Campaign - Engine V-Belt Guide Pulley Replacement

Campaign No. 2008070002, August 2008

Replace V-Belt Upper Guide Pulley

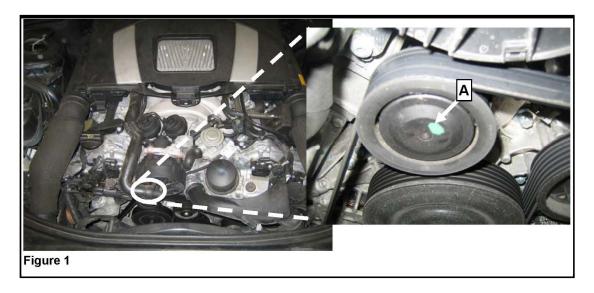
2. Remove plastic cap (A, Figure 1) covering pulley bearing and discard.

Note: Do not reinstall cap (A, Figure 1).

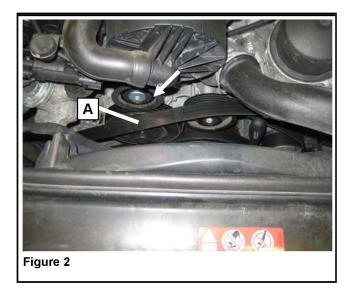
3. Remove V-belt (A, Figure 2) from pulley (arrow); refer to WIS for models:

- ^ Do not replace belt tensioner.
- 4. Replace guide pulley (arrow, Figure 2), torque guide pulley bolt to: 35 Nm.
